STATE OF NORTH CAROLINA
DEPARTMENT OF TRANSPORTATION

Subject: **Application for Modification to Section 404 Individual Permit and 401 Water Quality Certification** for the Widening of Davis Drive (SR 1613/SR 1999) from Morrisville-Carpenter Road in Wake County to NC 54 in Durham County, State Project No. 98051713, WBS Element 35018.1.1, TIP No. U-4026.

The purpose of this submittal is to request a modification to the Section 404 Individual Permit and Section 401 Water Quality Certification. The North Carolina Department of Transportation (NCDOT) has commenced construction of the subject project. Stability issues at five locations on the project will require permit modifications from USACE and NCDWQ. The changes are summarized in Table 1 and described below.

PERMIT SITE 3
PLAN VIEW

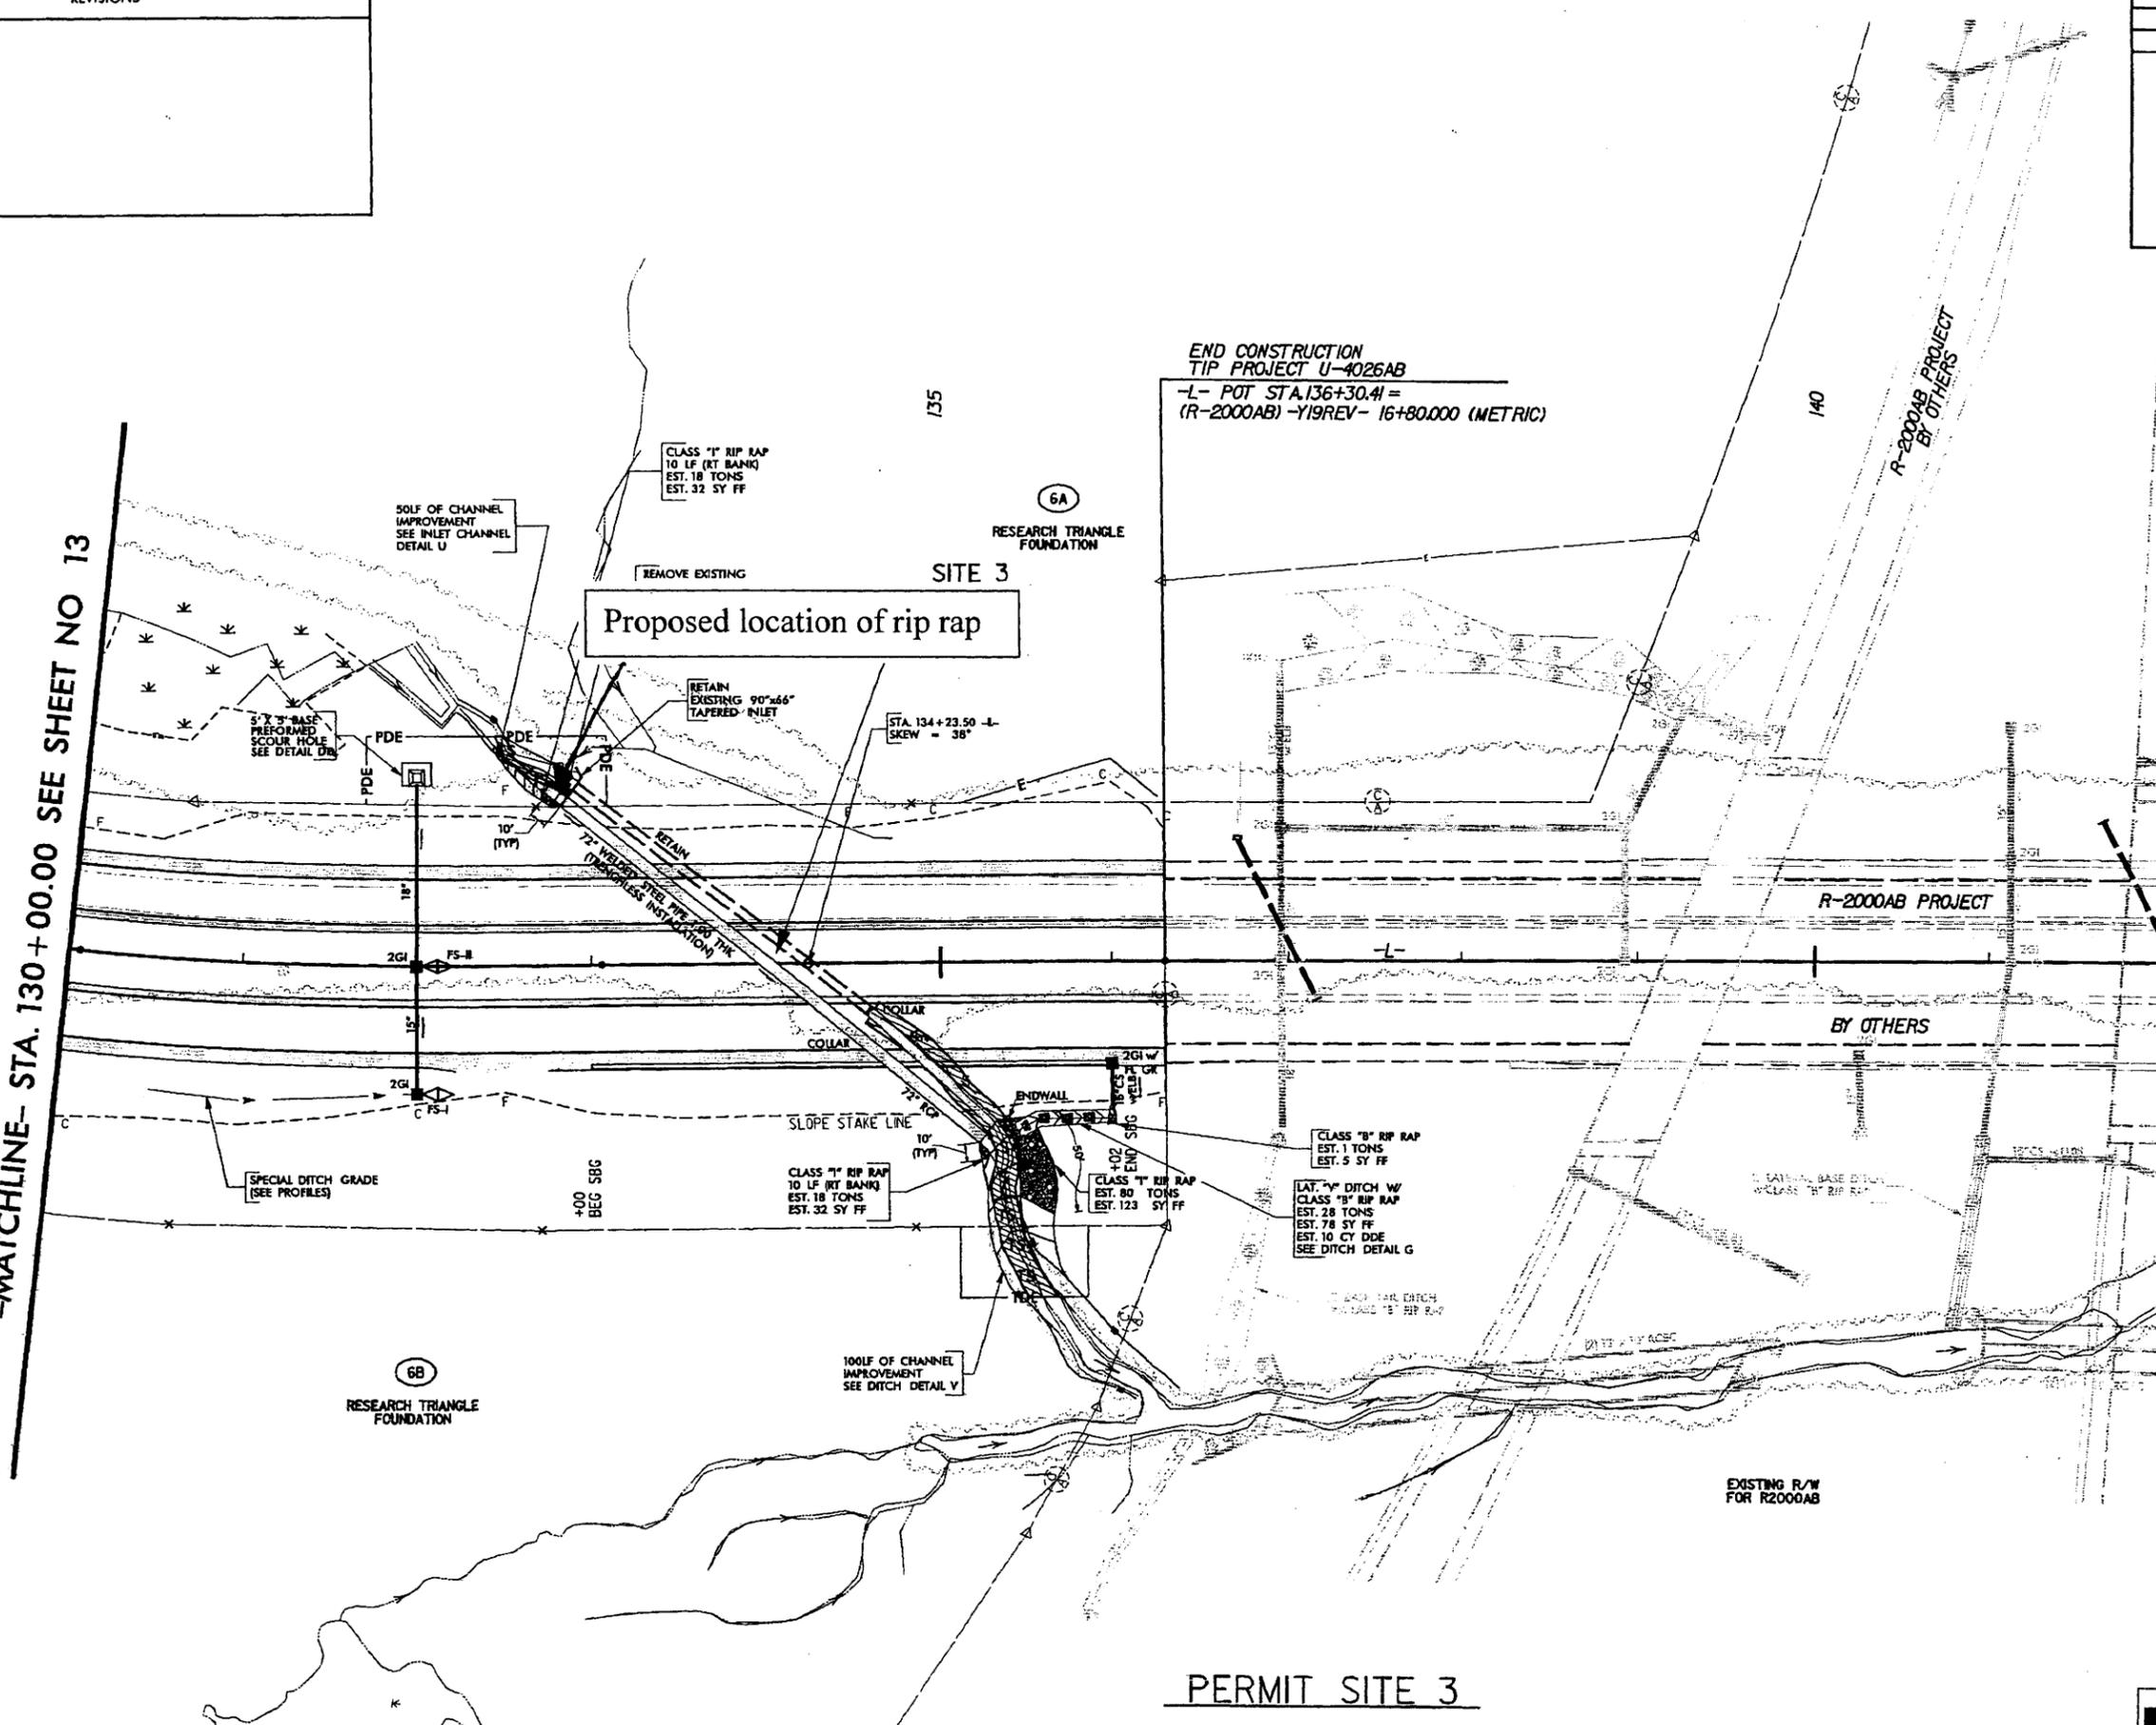
Permit Site No. 3 (Sheet 10 of 65) at 132+95 Lt.

NCDOT has completed the trenchless installation of a 72 inch steel pipe and associated channel improvements. Water is currently being ponded in an adjacent low area located in a sewer line easement to the west of the channel. Runoff from the ponded area during a rain event is being conveyed down the streambank into the channel. The runoff is resulting in the formation of a scour on the west streambank. A review of the previously submitted Sheet 10 of 65 indicates the installation of 10 feet of rip rap on the east streambank. NCDOT proposes to install Class I rip rap on the west streambank within the same limits as already permitted on the east streambank.

Proposed location of rip rap

The installation of Class I rip rap on the west streambank is located within an area depicted as fill in surface waters. No new impacts to jurisdictional resources will occur from this activity.

PERMIT SITE 7
PLAN VIEW

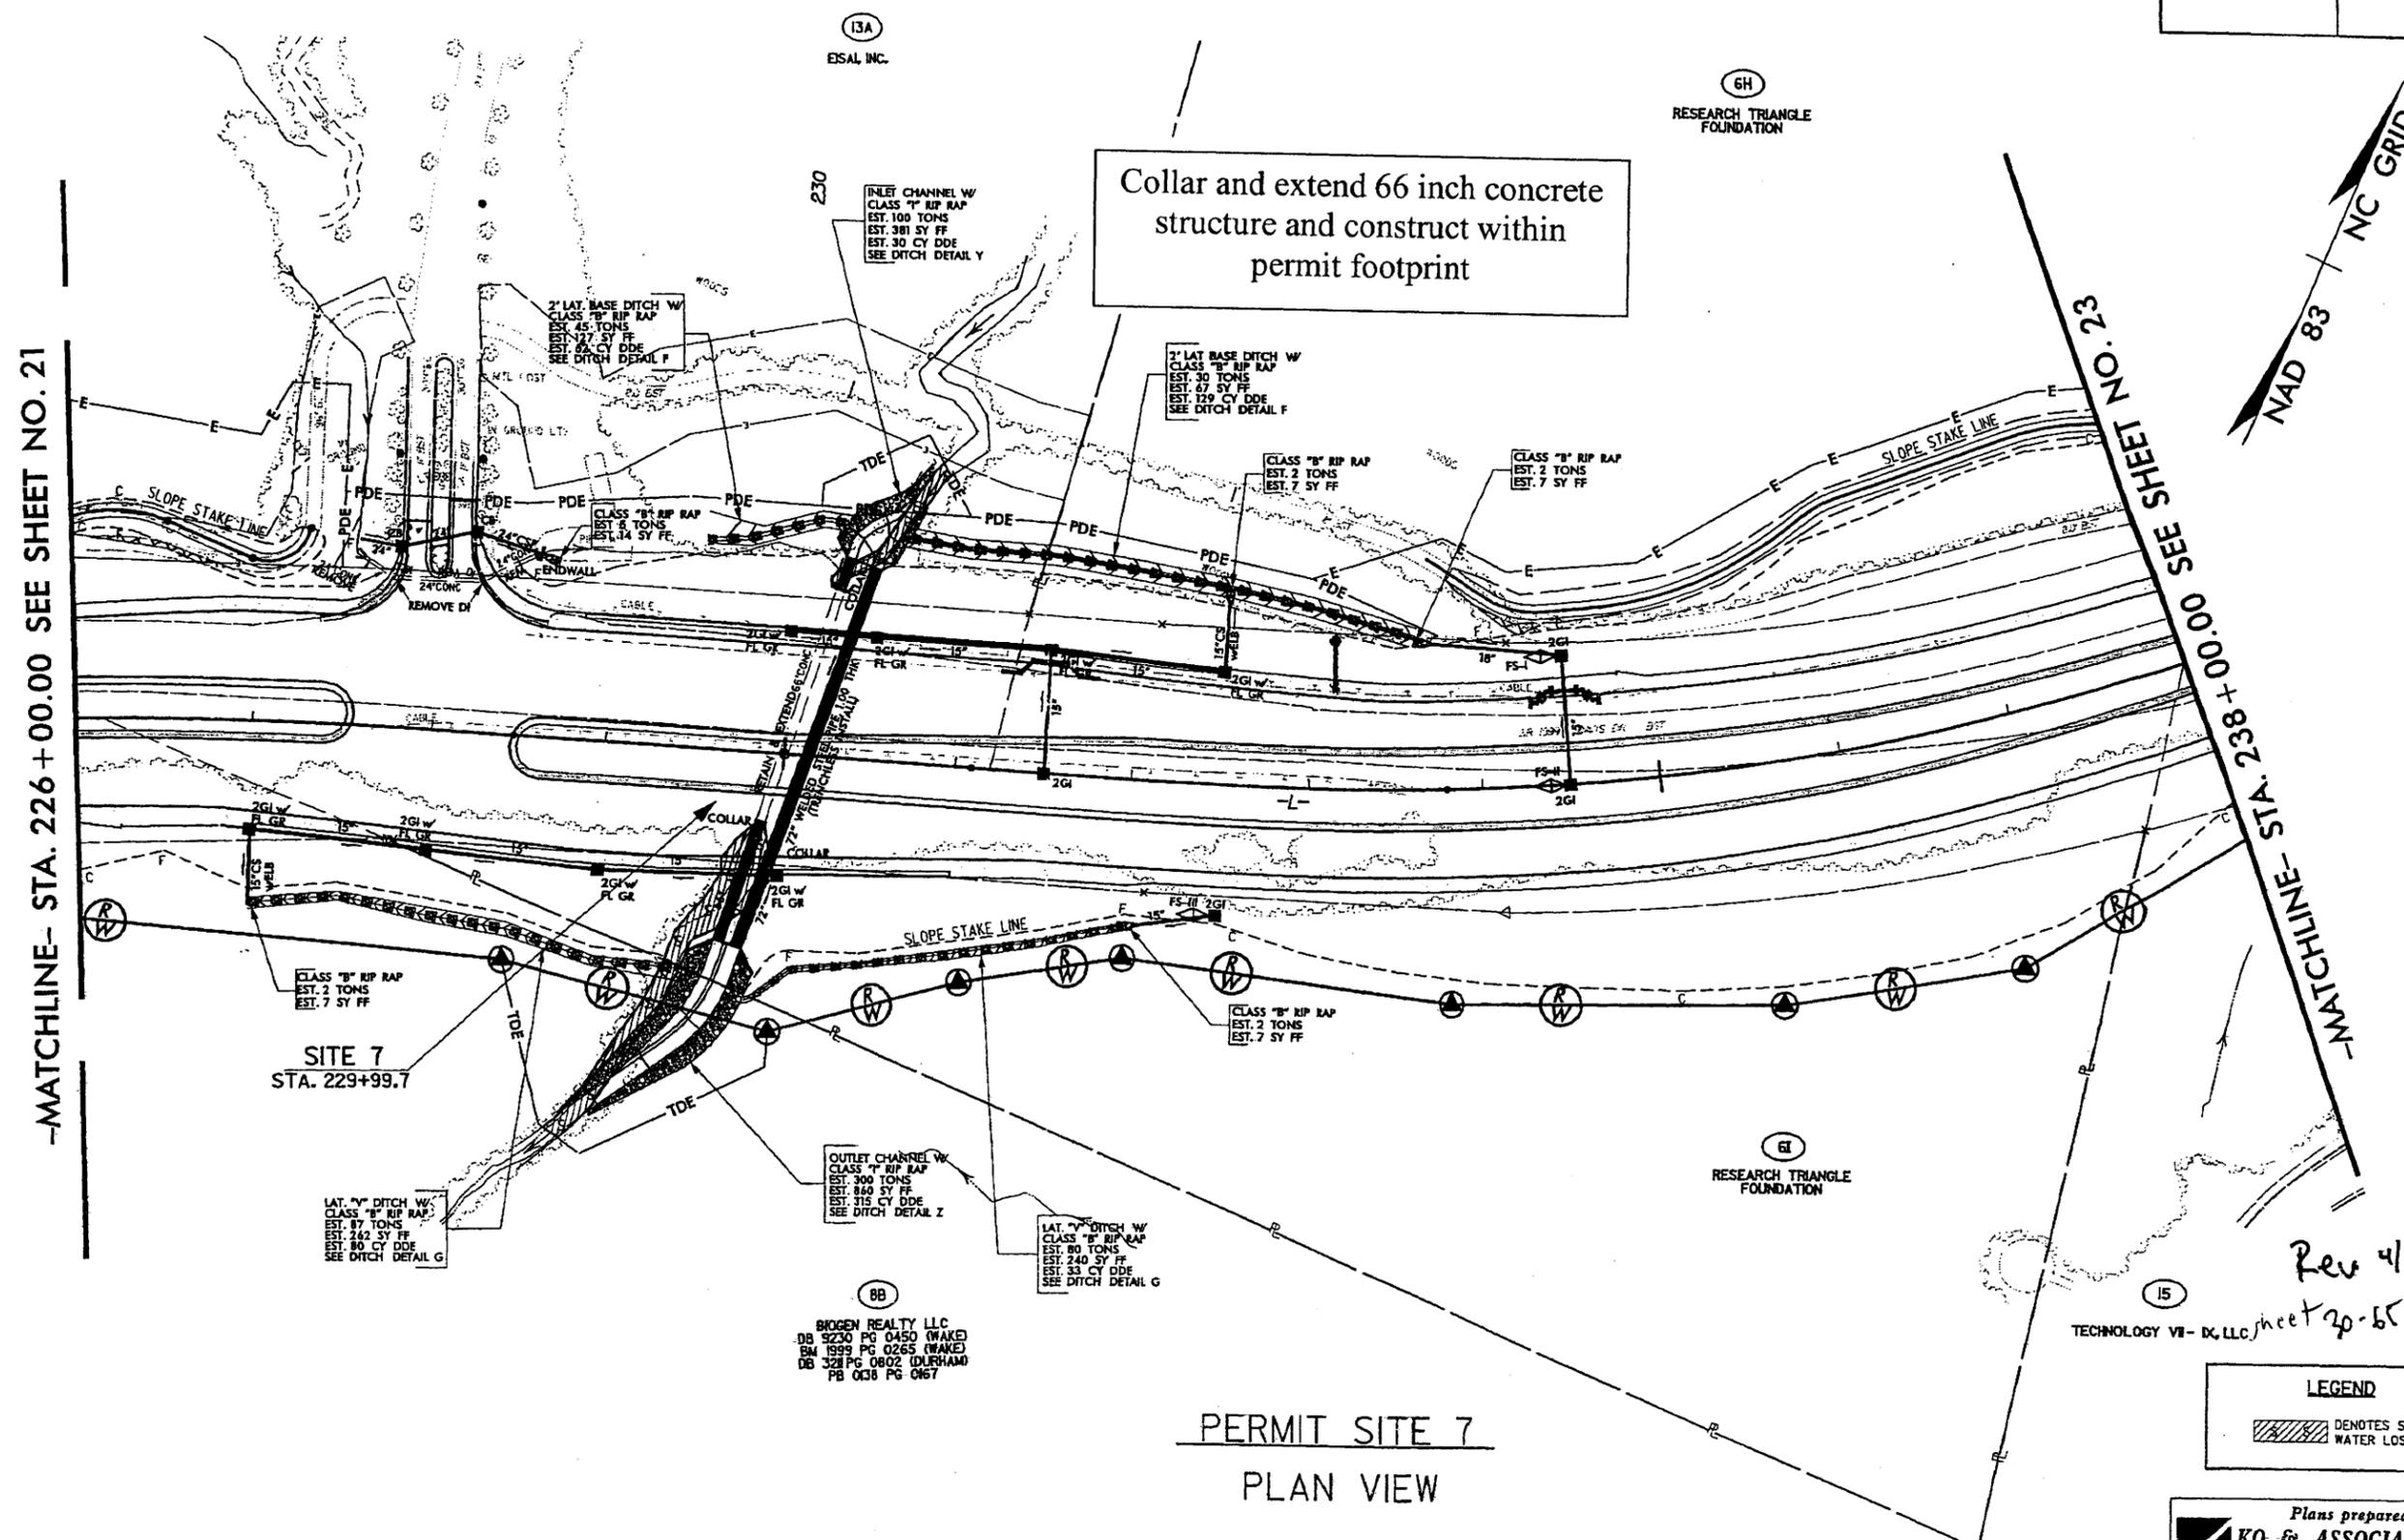
Permit Site No. 7 (Sheet 30 of 65) at 230+00

Construction at this site involves the extension of an existing 66 inch concrete structure and the trenchless installation of an adjacent 72 inch steel pipe. A significant amount of Class I rip rap is proposed to be installed on the streambanks at the inlet and outlet of the structures to allow the proper transition into the stream outside of the construction limits.

NCDOT proposes to revise the construction activity at this site due to the proposed design of the future Triangle Parkway (U-4763B) project which will install 2, 8 foot x 7 foot box culverts. Since there it is likely that the Triangle Parkway project will be funded and built, NCDOT suggests that it is unnecessary to expend the time or money to install the 72 inch steel pipe at the crossing. NCDOT proposes to collar and extend the existing 66 inch concrete structure (as originally proposed) and conduct adequate up and downstream channel improvements and bank stabilization to provide a stable transition into the existing stream.

Collar and extend 66 inch concrete structure and construct within permit footprint

The Sheet indicates that all activity located within the permitted footprint is depicted as permanent fill in surface water. All proposed construction activity will occur within this permitted footprint and therefore will not result in additional jurisdictional impacts.

DETAIL OF RIP-RAPPED OUTLET ENERGY DISSIPATOR BASIN

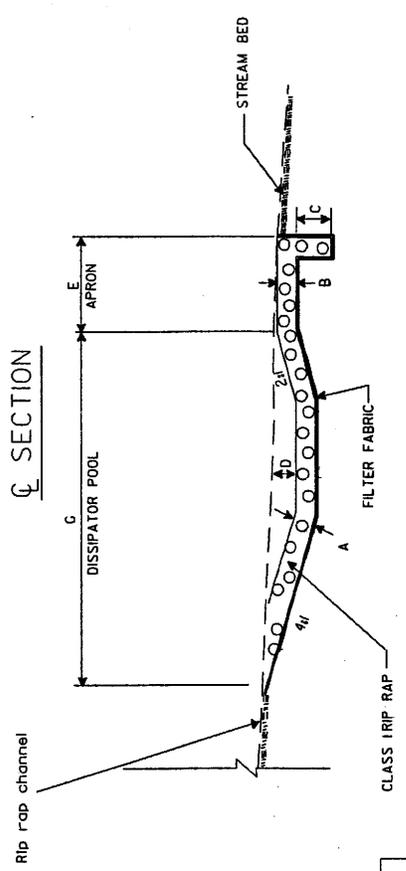
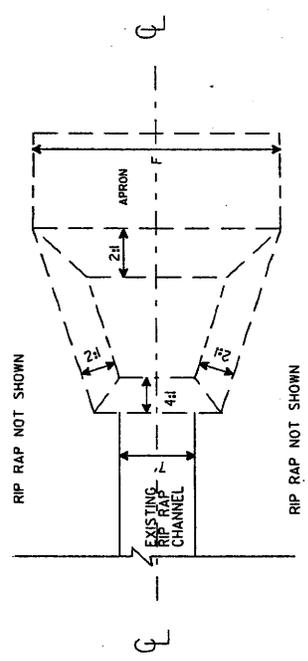
Permit Site No. 1 (Sheet 5 of 65) at 91+00 Rt.

Off-site development has placed rip rap in a channel upstream of the project that extends in the stream into the NCDOT right of way (ROW) for approximately 32 feet. Please note that the NCDOT has never approved this encroachment into the ROW. Stormwater runoff from the off-site development has caused the destabilization of the rip rap in the channel and the formation of a headcut in the channel located in NCDOT ROW. A previous attempt to stabilize the channel had been made at this site by installing larger-size rip rap. However, the site continues to destabilize as

the streambed has washed to a layer of Triassic rock and rip rap is pushed further downstream in the channel.

NCDOT proposes to excavate the footprint of the rip rap installed by the off-site developer in the ROW and construct a rip rap outlet energy dissipater in this same location. There will be no new impacts to the channel as the energy dissipater will not exceed the footprint of rip rap previously installed by the off-site development. The energy dissipater should reduce runoff velocity and stabilize the head cut.

The footprint of this proposed activity is located in an area depicted as both temporary fill in surface waters and fill in surface waters (with rip rap only on the banks). NCDOT only proposes to construct the energy dissipater within the footprint of rip rap previously installed by the off-site development in the NCDOT ROW, therefore there will be no additional impacts to the stream.

LOG VANE WEIR DETAIL

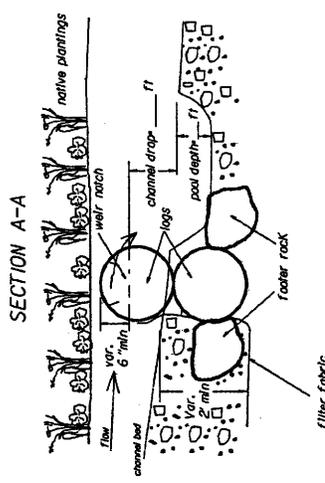
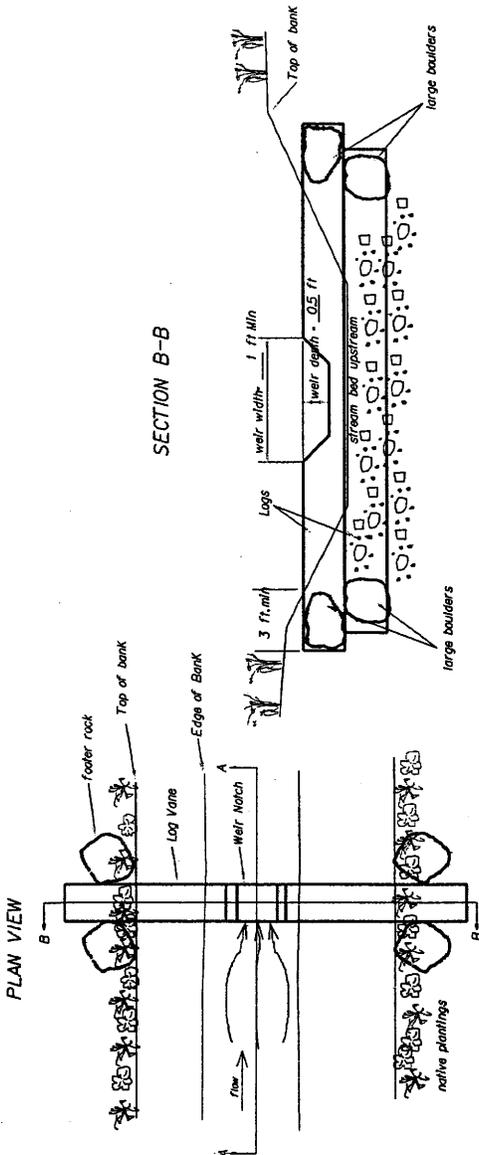
Permit Site No. 1 (Sheet 5 of 65) at 91+90 Rt.

An intermittent stream flows into NCDOT ROW near 91+90 Rt. A review of this stream prior to construction activity at the site revealed that the channel had headcut up to an off-site headwater wetland. Construction activities at the stream included both bed and bank excavation. NCDOT proposes to install a log vane weir in the stream channel to serve as a grade control structure to prevent additional headcutting at the site (see attached log vane details).

The installation of the log vane weir is located within an area depicted as fill in surface waters. No new impacts to jurisdictional resources will occur from this activity.
